UPDATE TO INSTALLATION INSTRUCTIONS FOR PART NUMBERS 1010 & 1020.

Mirror part number affected: 1020.

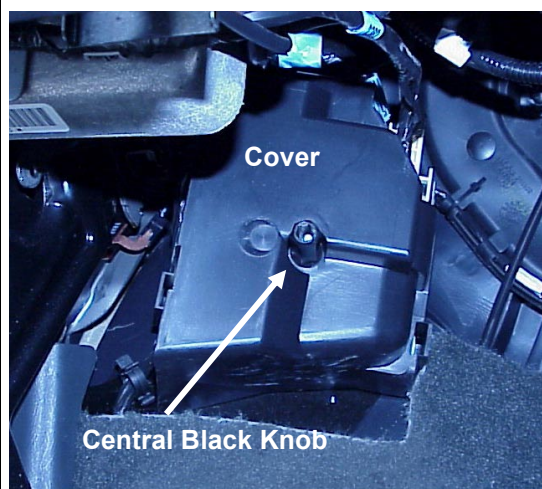
Vehicle Model - Pre MY 2003 GMC, Chevrolet and Cadillac vehicles. Problem with installation steps no. 31 and 32- No orange connector on passenger side?

On the passenger side fuse panel, your vehicle may not have an orange connector to attach the passenger side mirror yellow wire.

The yellow wire operates the clearance light function on the mirror, so this needs to be wired into a suitable vehicle circuit.

Extend the yellow wire by another six feet so it can reach the circuit identified in step 31. This means that the yellow wire from both mirrors will be wired into the same circuit.

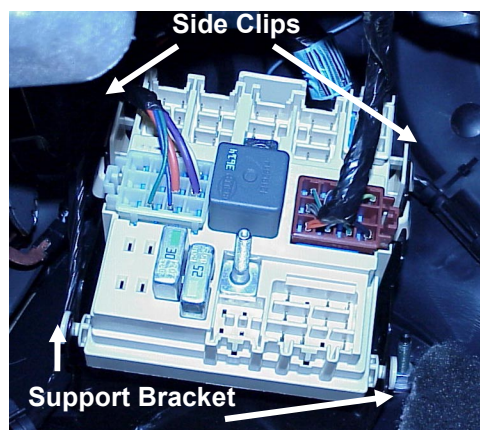
Vehicle Model – Post MY 2003 GMC, Chevrolet and Cadillac vehicles. Problem with installation step no. 30.

There is no need to disassemble the vehicles dash for connection of the yellow clearance light wire. If you attach the yellow wires as outlined in step 30, the mirrors clearance lights will dim with your instrument panel dimmer switch.

To avoid this, after step 29 remove the junction box cover located to the left of the driver's foot brake. The cover can be removed by turning the central black knob off and pulling the cover.
